VEHICLE		FREE TRAVEL	CLUTCH KIT	COVER ASSEMBLY	DRIVEN PLATE	RELEASE BEARING

**▲⁸ MINOR 1000 RANGE
INABILITY TO SELECT GEARS**

**▲⁹ ROVER SD1 2000, 2300, 2400 DIESEL, 2600 AND 3500
IMPROVED CLUTCH SPECIFICATIONS**

**▲¹⁰ ROVER 2300 and 2600 1977→
DIFFICULT GEAR SELECTION**

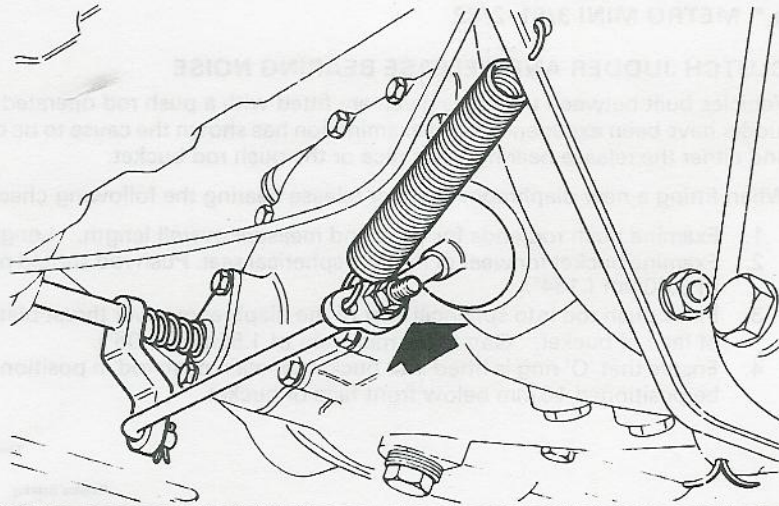
Insufficient release bearing/release plate clearance on the above vehicles can cause an overstroking condition leading to the above complaint. Other problems could be clutch slip or driven plate damage.

Correct clearance is achieved by setting the clutch pedal free travel, which for vehicles with 1098 cc. engines must be 35–38 mm ($1\frac{3}{8}$ "– $1\frac{1}{2}$ " measured at the pedal pad. (For earlier vehicles prior to the 1098 cc. engine the setting must be 19 mm ($\frac{3}{4}$ ".))

Set the pedal free travel by adjustment of the clutch operation rod as shown in the illustration.

ADJUST HERE TO SET PEDAL FREE TRAVEL TO 34.9–38.1 mm ($1\frac{3}{8}$ "– $1\frac{1}{2}$ ".)

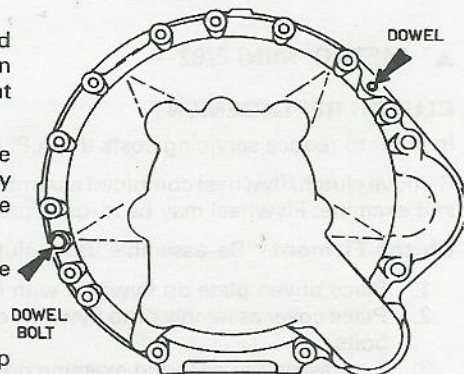
Examination of clutch assemblies returned for these complaints has revealed excessive wear on the diaphragm spring fingers and driven plates with broken centres. Investigation has shown this type of failure to be caused by misalignment between the engine and gearbox.

Correct alignment of the engine and gearbox on these vehicles is achieved by the use of a dowel and a special dowel bolt. It has been found on some vehicles, especially those where the engine or gearbox may have been removed previously; that the dowel and/or bolt have been either incorrectly fitted or omitted.

Before re-assembly of the gearbox to engine is carried out check the adaptor plate for flatness or distortion, then carry out the following procedure:

1. Align gearbox input shaft with driven plate splined hub.
2. Slide input shaft into splined hub and locate bellhousing on the dowel in top right hand of the casing making sure that the dowel is not pushed back through the adaptor plate. (See diagram.)
3. Locate and fit dowel bolt in its correct position in the lower left hand side of the bellhousing and refit the locking nut. (See diagram.)
4. Refit the remaining bolts and nuts.
